October 3, 1980

Re: Nine Mile Point Unit 2
Docket No. 50-410

Your letter of July 9, 1980 requested additional information regarding geology at Nine Mile Point Unit 2. Enclosed are Niagara Mohawk's responses to questions Q361.26 through Q361.35 contained in the enclosure to your letter.

VERTICAL SWELL STRAIN RATE'
V.S. FIRST STRESS INVARIANT - TRANSITION ZONE

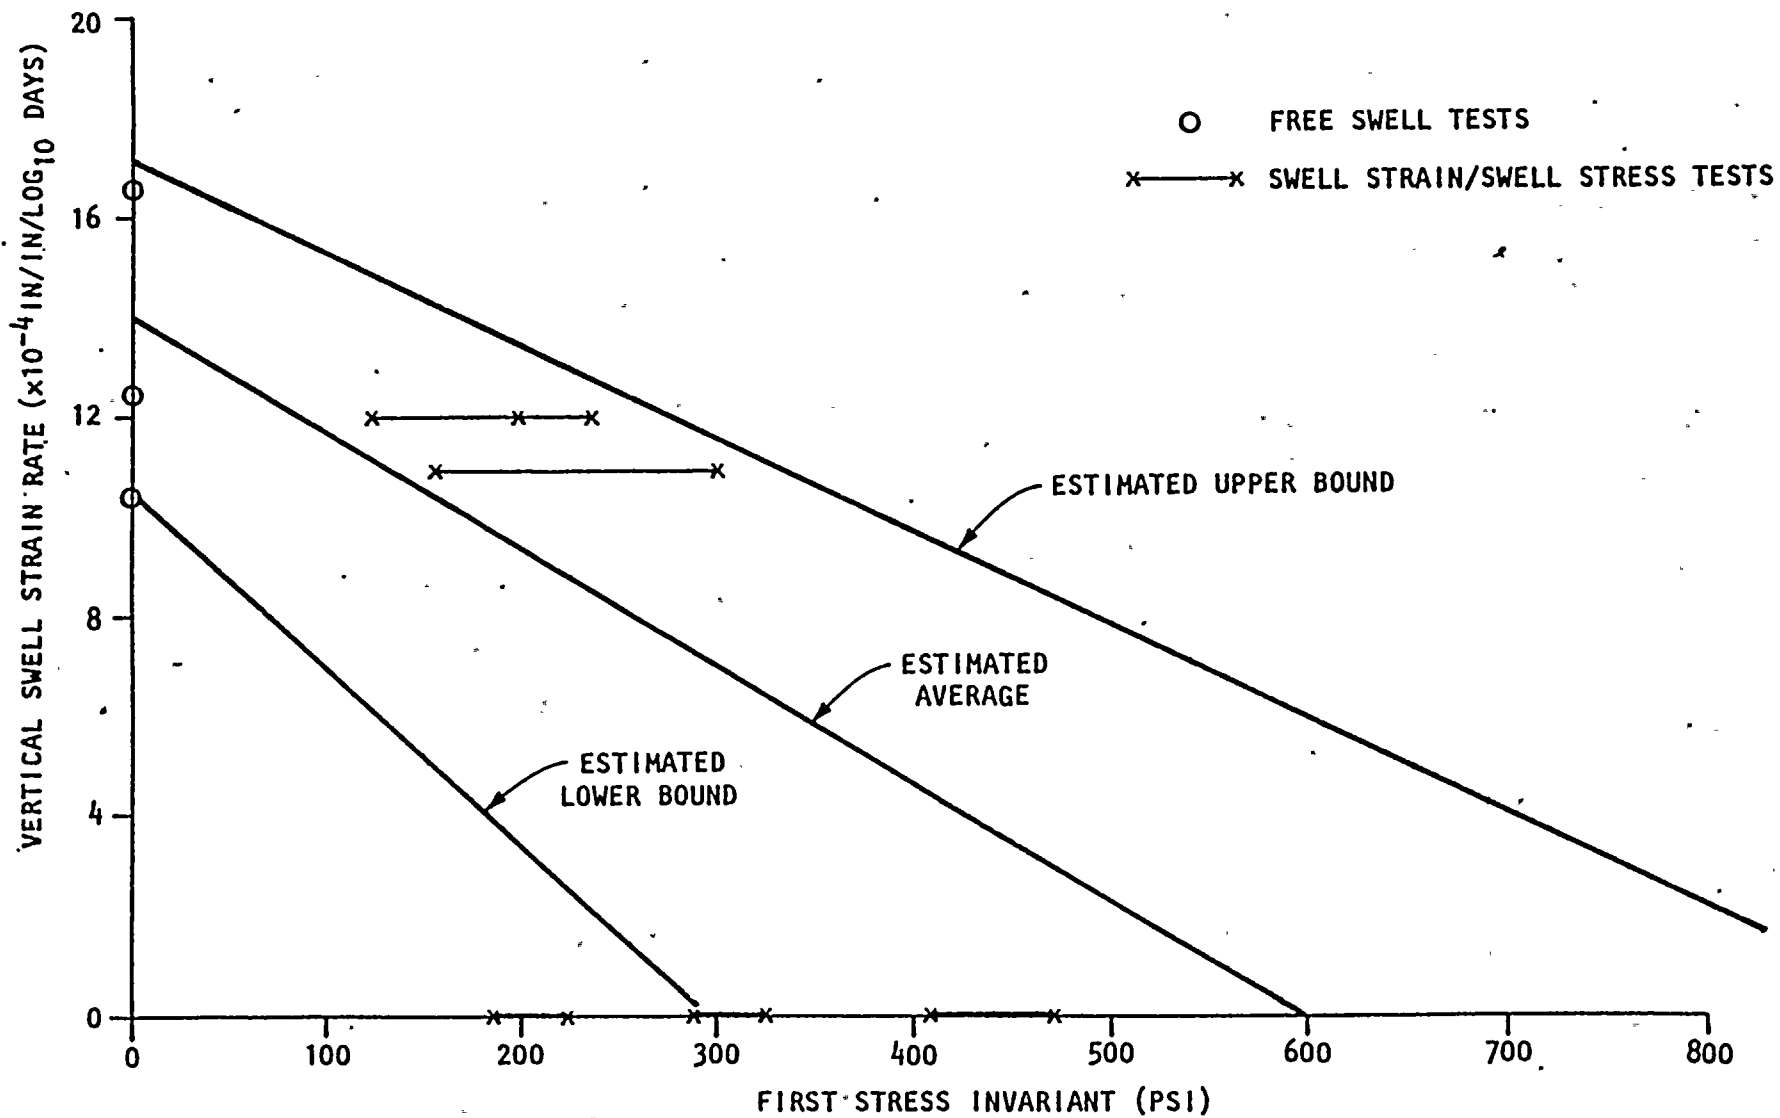
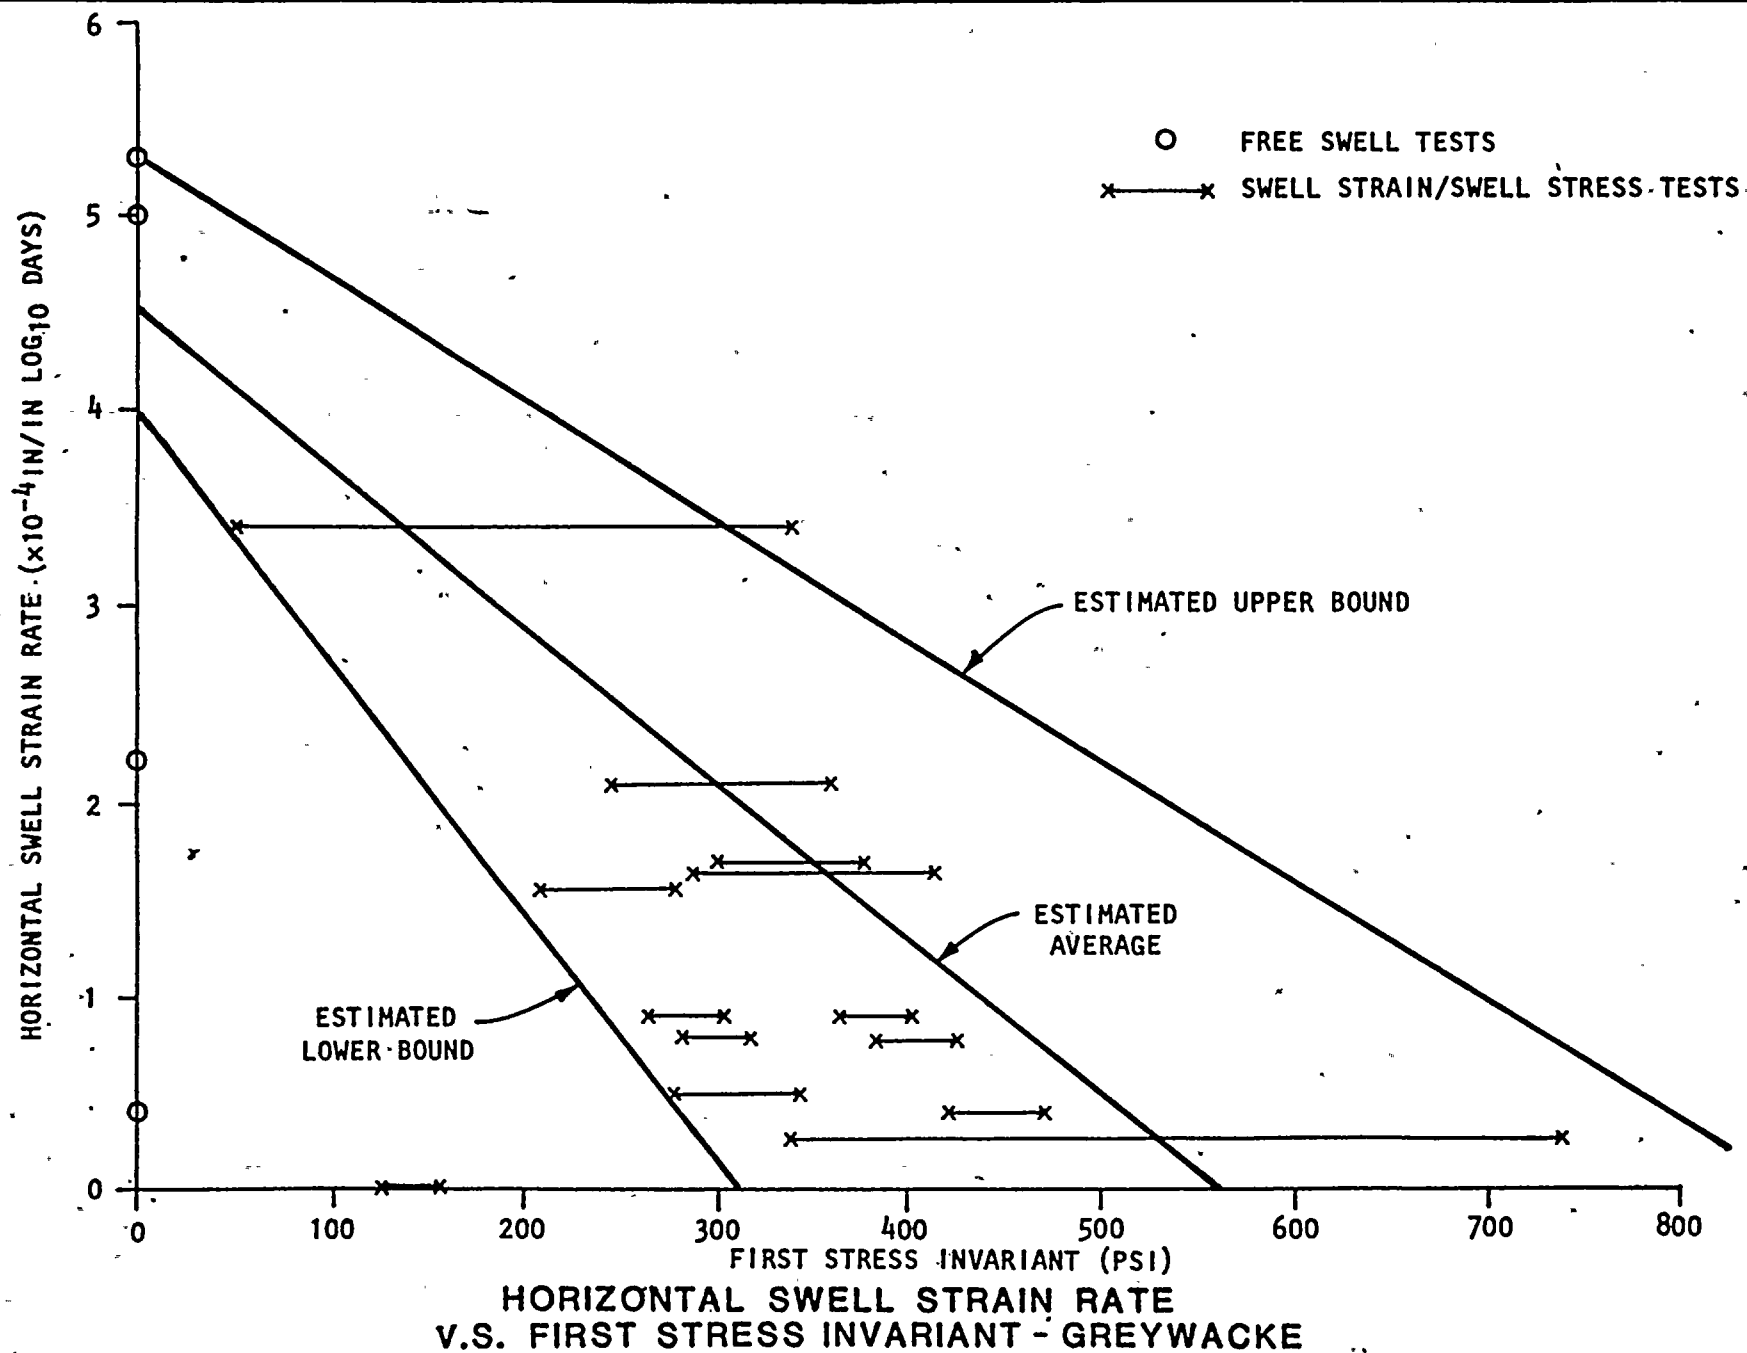
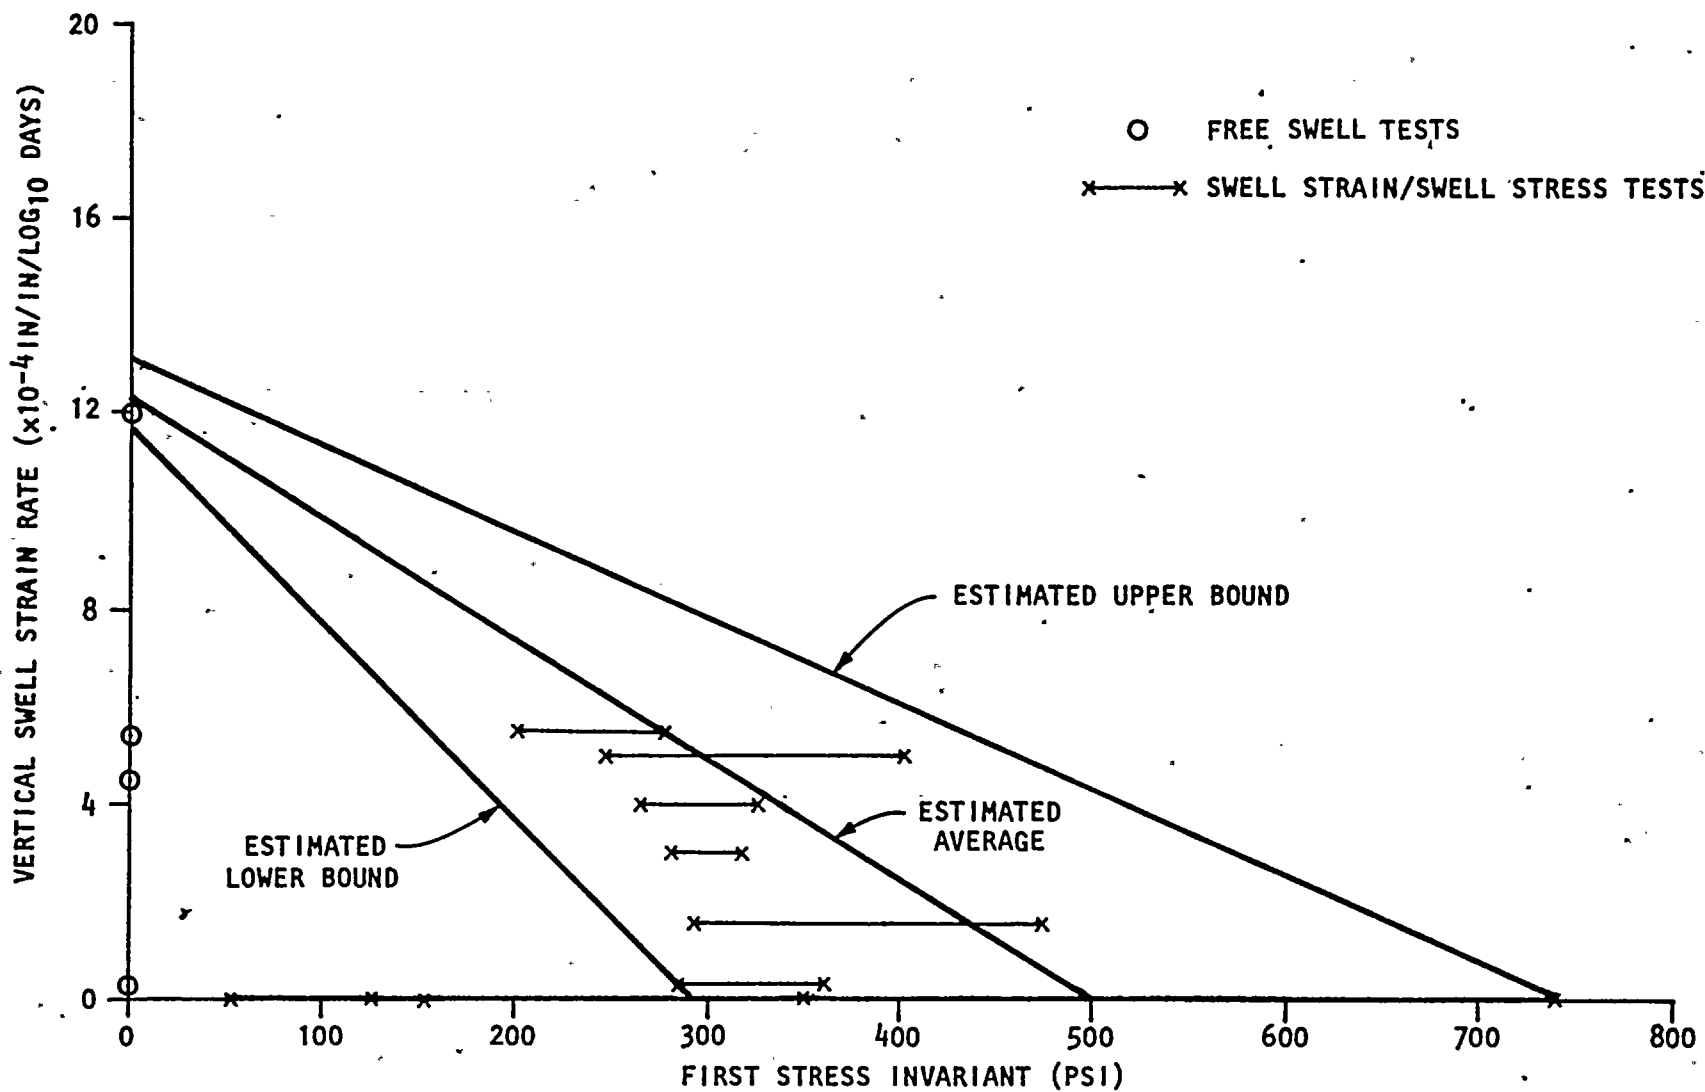
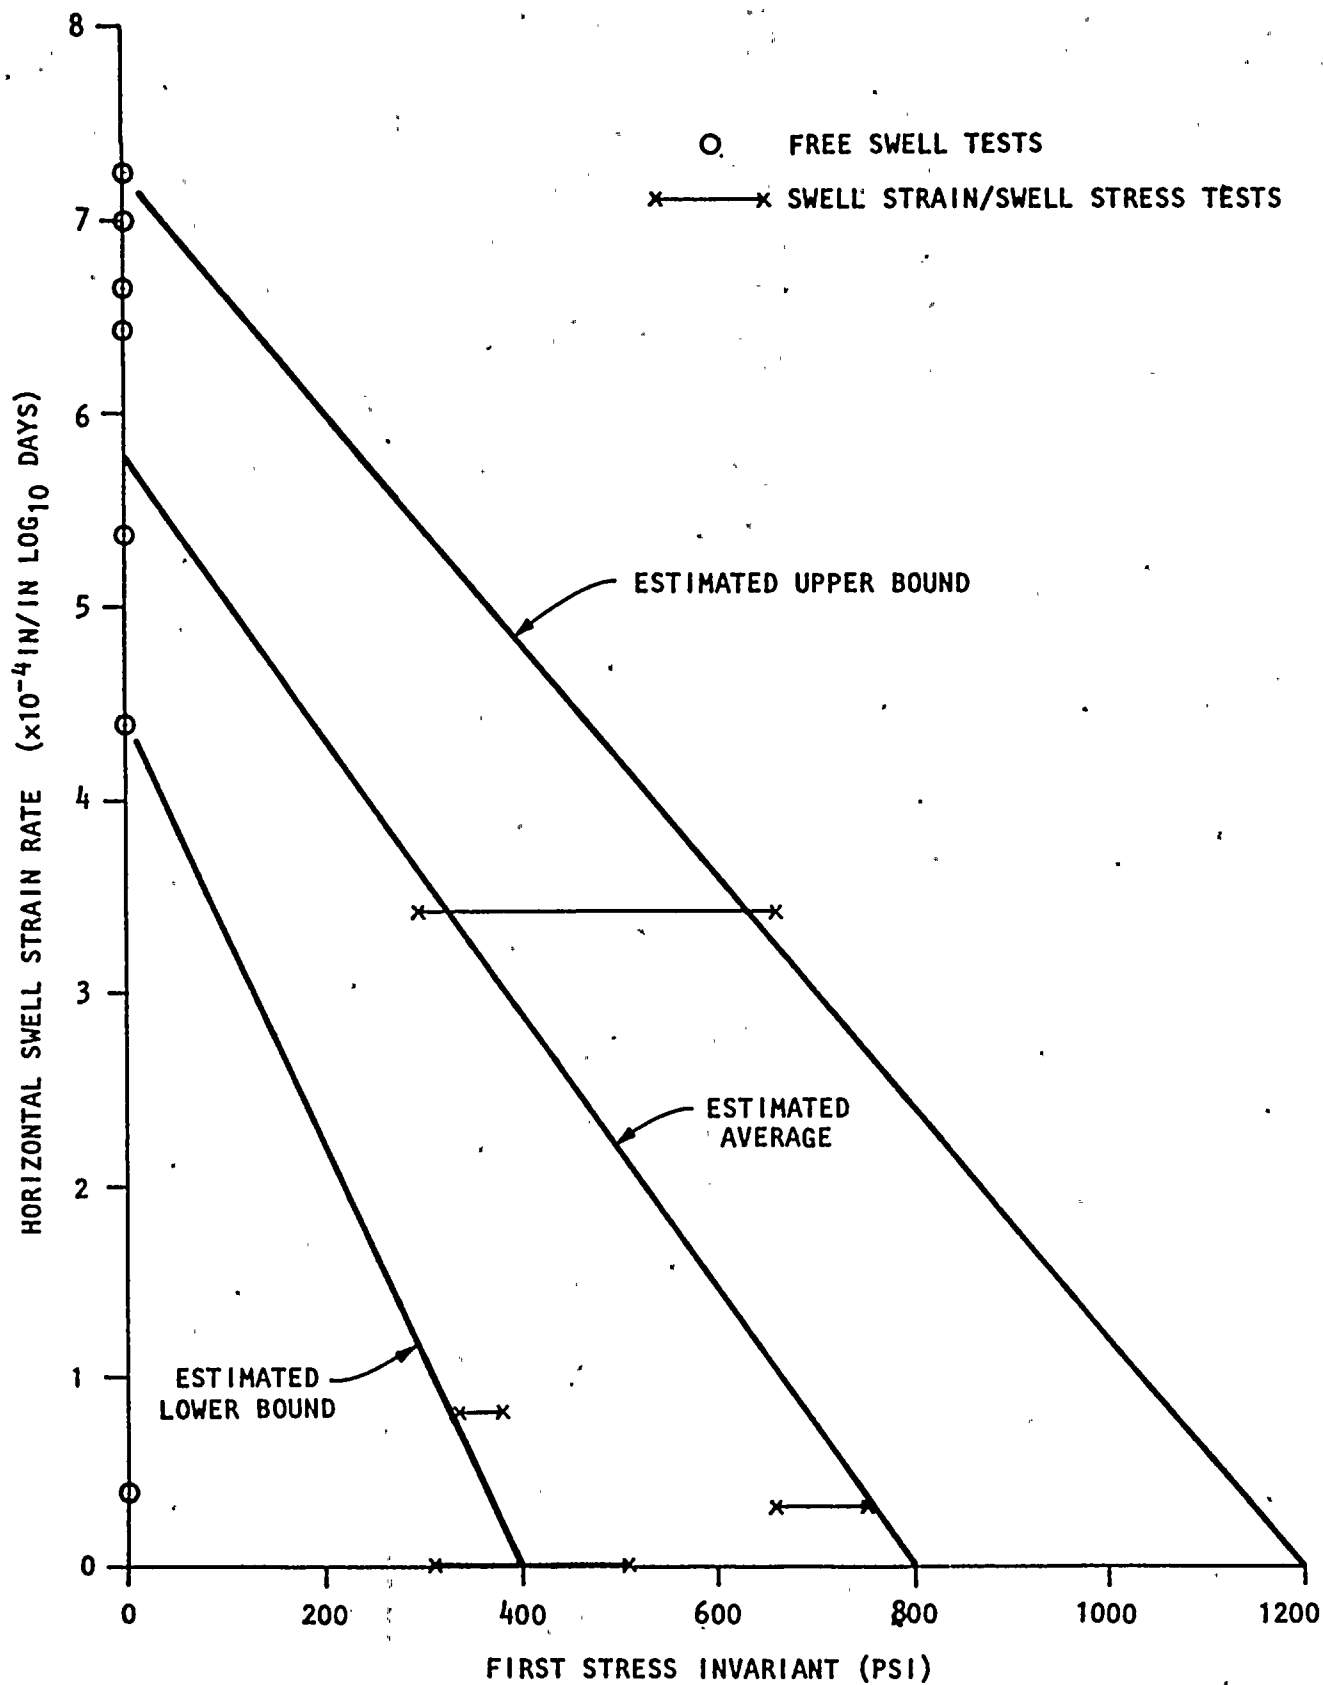
Q361.34 Substantiate the argument presented in Section 2.6 of your Summary that swelling stresses may have resulted from fluctuations in water level in Lake Iroquois. Show that rocks at the site can develop a swelling stress under confined conditions with water pressure varying from 1 to 10 atmospheres. Estimate how rapidly Lake Iroquois must have drained so that residual pore pressures could approach lithostatic pressures. In this evaluation, use the permeabilities determined by pumping test in the upper 200 feet of rock in this area.

The results of the oedometer ring swell tests are presented on Figures 361.34-1 through 361.34-8. The Figures show the relations of the swell rates as a function of the first stress invariant, which is the sum of the principal stresses. The rock units within which the Cooling Tower Fault is developed were tested for swelling potential. The following conclusions can be reached, based on the data presented:

- (i) the swell strain rates are dependent upon the first stress invariant. The rates decrease linearly with the increase of the stress invariant;
- (ii) there exists a limiting value for the first stress invariant beyond which swell rate is equal to zero. The limiting value indicated by the results appears to be larger than approximately 450 pounds per square inch (first stress invariant corresponding to hydrostatic pressure equal to 10 atmospheres).

Hence, it follows that rocks present at the site can develop a swelling stress under confined conditions with water pressure varying from 1 to 10 atmospheres. However, in order to develop these strains, the in situ bedrock stress must be reduced below the limiting value of the stress invariant. From observations of bedrock dilations onsite, it is clear that the required reduction occurred simultaneously with the deformation. The residual pore pressure may have been important in triggering this deformation.
